Department of Environmental Quality

RE: Annual Inspection for parts of Parcels C, E, & F
North Ridge Estates Superfund Site
ECSI No. 6029

Lot LAM Inspection
2023 Annual Inspection Summary Report
North Ridge Estates - Operable Unit 1
Klamath Falls, Oregon

Apex Companies, LLC 15618 SW 72nd Avenue Tigard, Oregon 97224	Project Number: 32-23006007	Drawn: JP	Approved: MS/AB	Figure LAM.3
September 2023

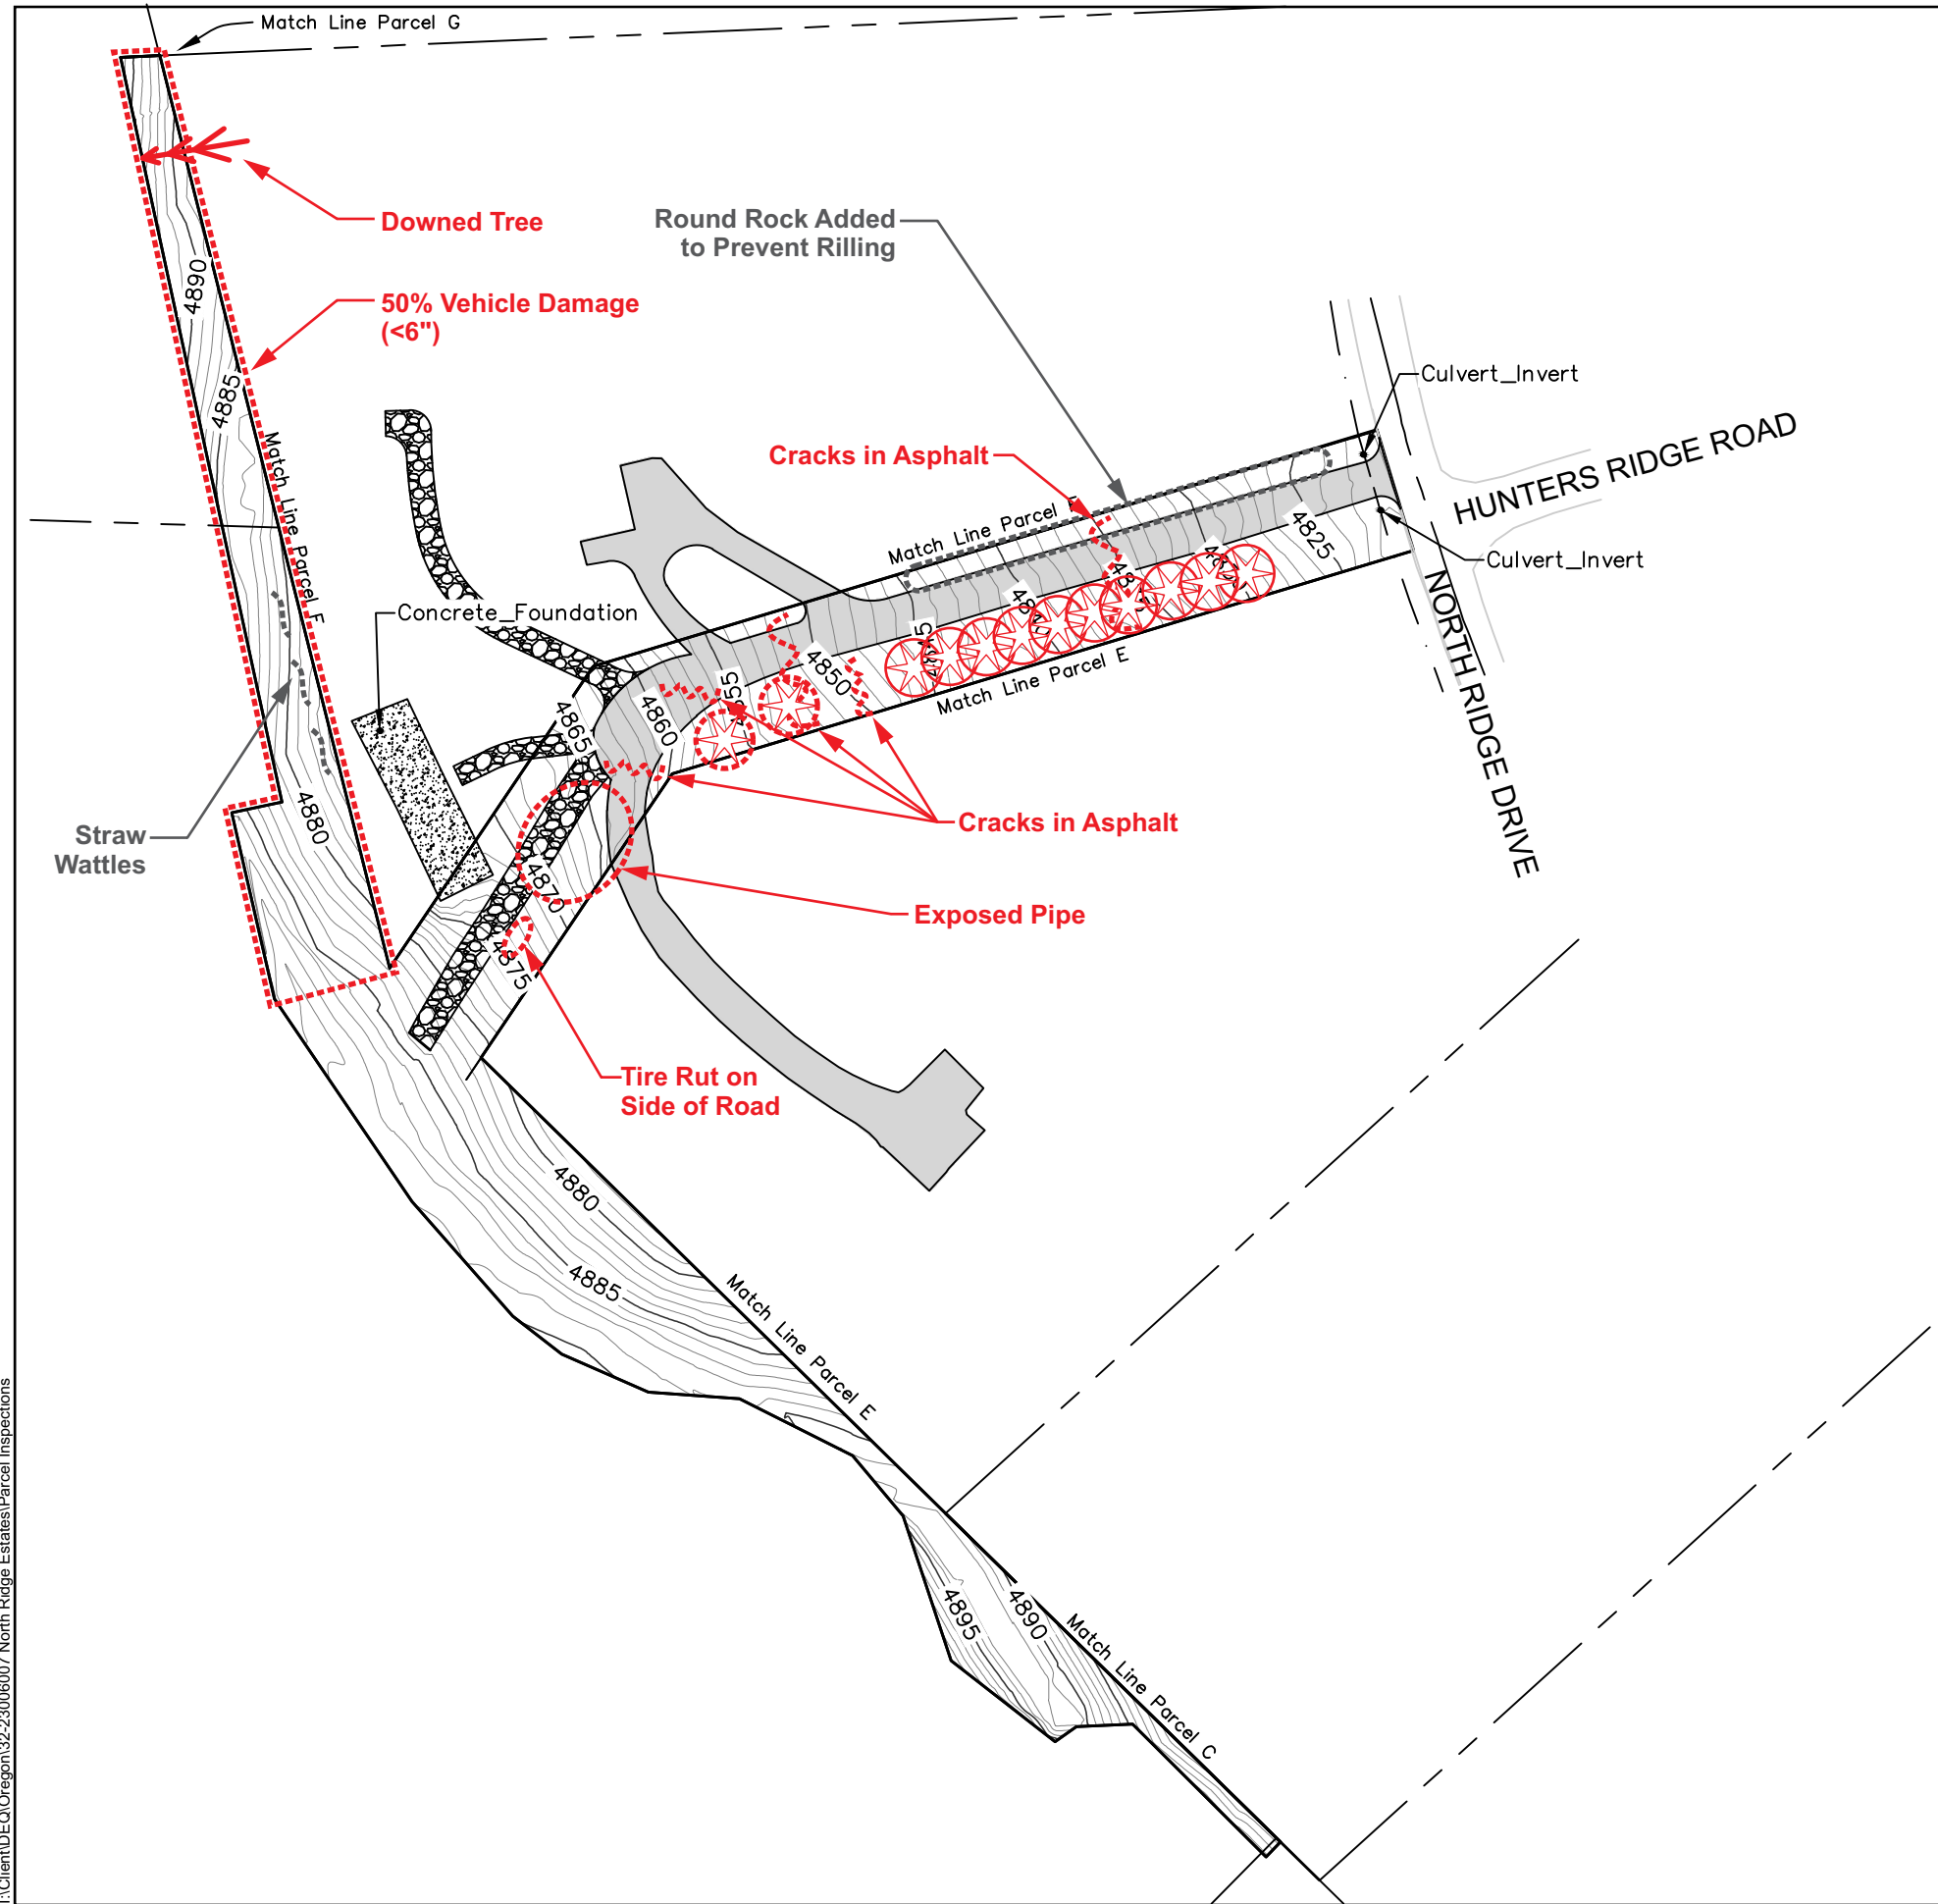
1. **Cap Damage.** Areas of damage to the soil protective cap by vehicles have been noted (see enclosed figure).

Corrective Action. Fill in the damaged areas. Armor as needed to prevent reoccurrence by November 12, 2023.
2. **Recommendations.** 1) Cover the exposed water line. 2) Seal cracks in the asphalt drive.
